APPLICATION NO.	FILING DATE	FIRST NAMED INVENTOR	ATTORNEY DOCKET NO.	CONFIRMATION NO.
10/765,107	01/28/2004	Han Ki Cho	9988.099.00-US	9733

Office Action Summary

DETAILED ACTION

FIG. 1A

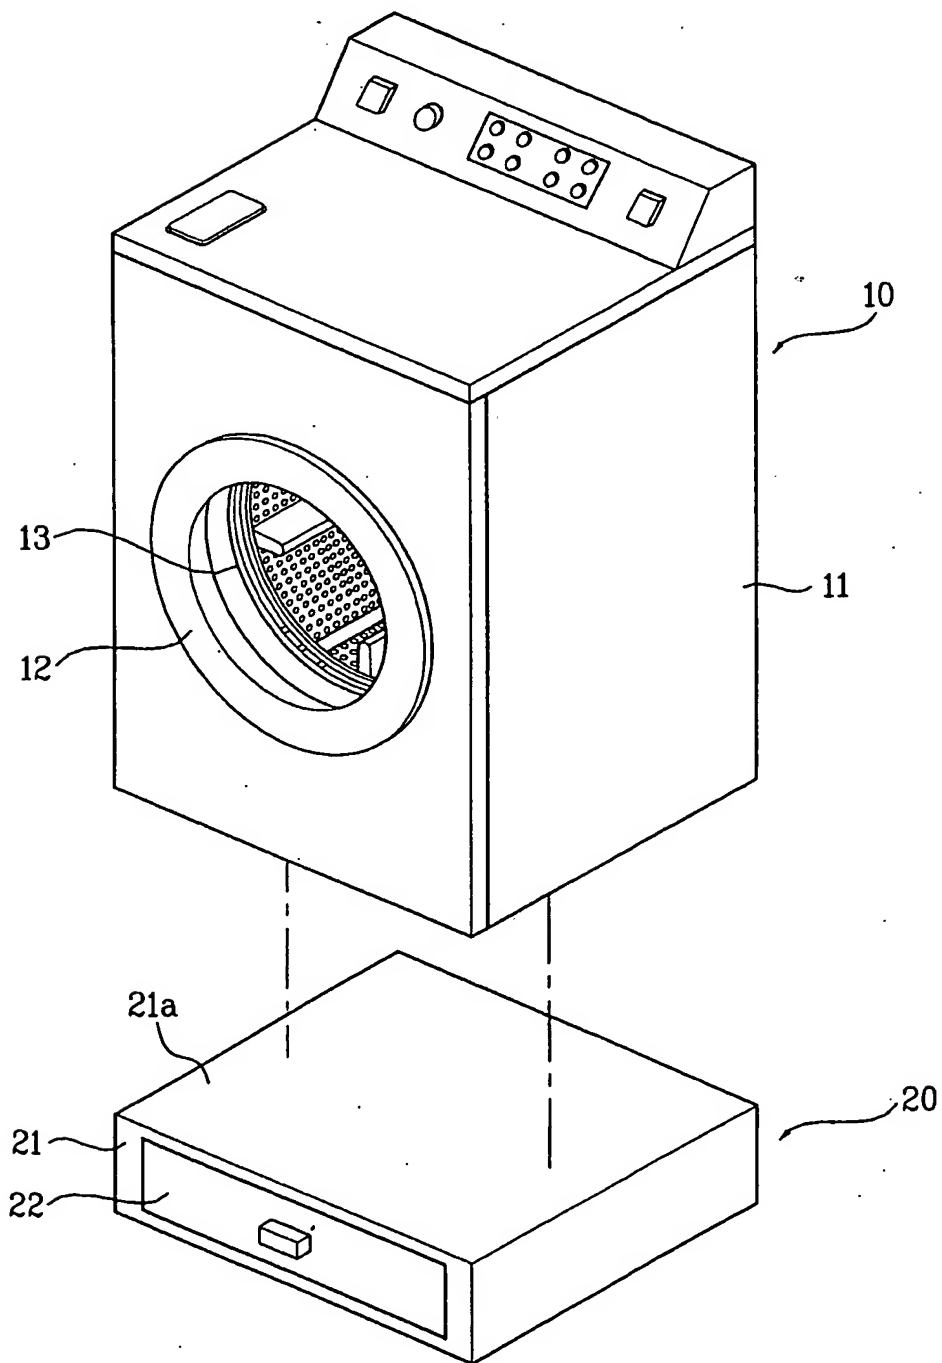
5. Claims 1-5, 9 & 10 are rejected under 35 U.S.C. 103(a) as being unpatentable over Applicant's Prior Art Admission – figures 1A-1B and correlating information disclosed in the specification [known hereafter as APAA] in view of Sill [U.S. Patent No. 6,578,902]. APAA (figure 1A) teaches of a pedestal (20) used in conjunction with a washing machine (10), the pedestal comprising: a pedestal body (21) supporting a bottom portion of the washing machine; but APAA does not show a coupling means provided to lateral sides [interpreted as meaning the vertical or upright sides] of both the machine and the body. Sill (figures 1-5) teaches of a coupling means (fig. 4) utilized to join to two adjacent members (115, 116) together that are arranged along the same plane. The coupling means includes a coupling member (123) that could be provided on both lateral sides of the washing machine and the pedestal body [which is located directly beneath the washing machine], and a fastening member (126) that is capable of fastening the coupling member to the side of the washing machine and to the side of the pedestal body, respectively; wherein the fastening member includes, a first fastening member (one 126 – double-sided tape is one option disclosed in the specification) capable of fastening an upper part (viewed as the right side since rotated 90 degrees when attached) of the coupling member to the side of a lower part of the

Approved for examination purposes
Apr 5/16/06

FIG. 1B

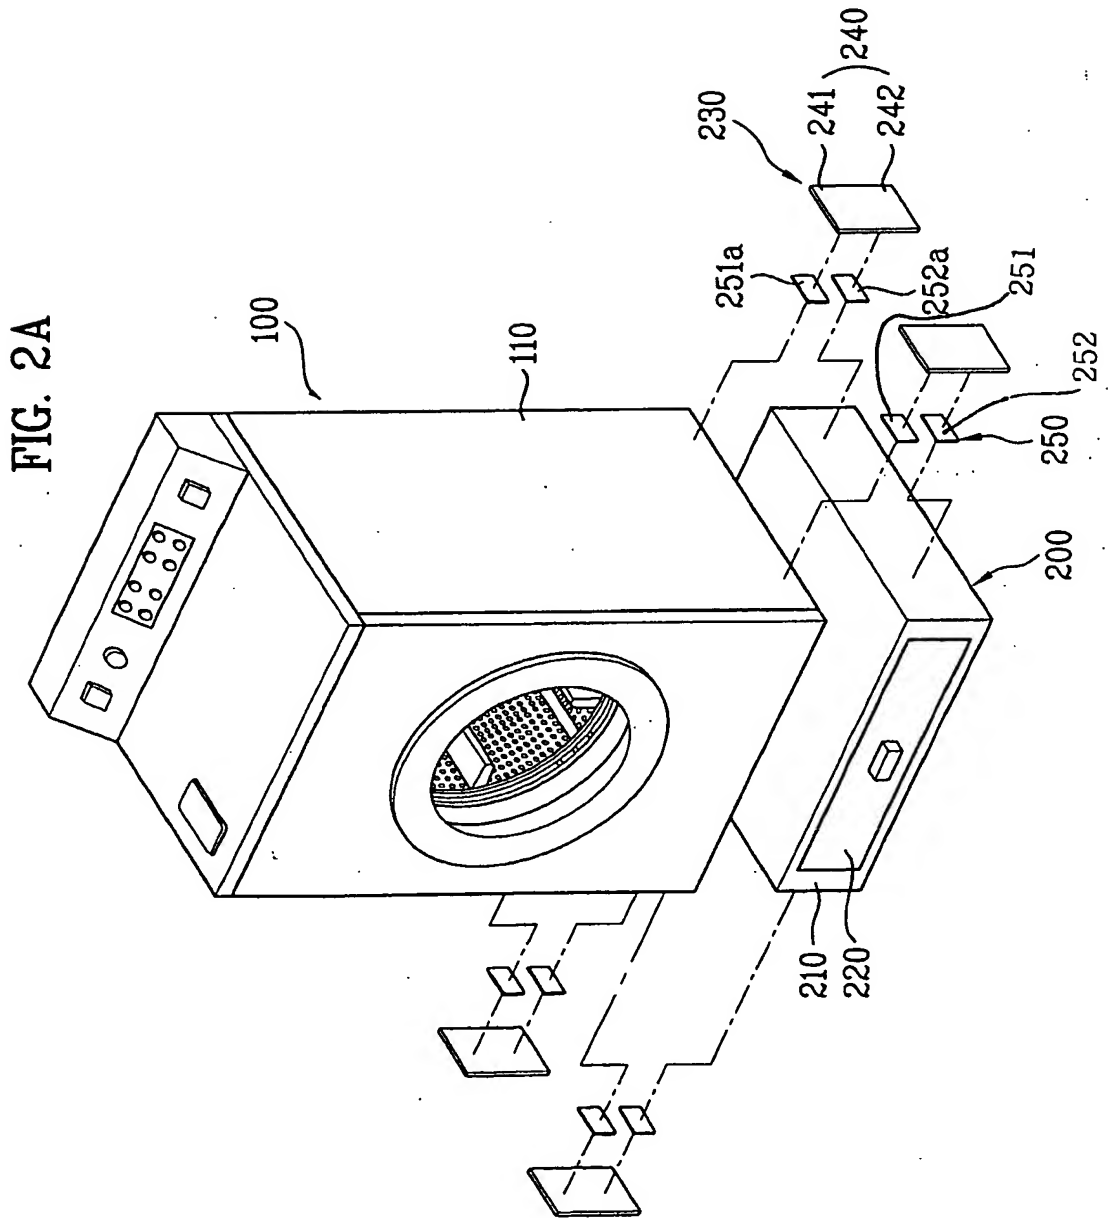
Approved for examination purposes
Jah 5/16/06
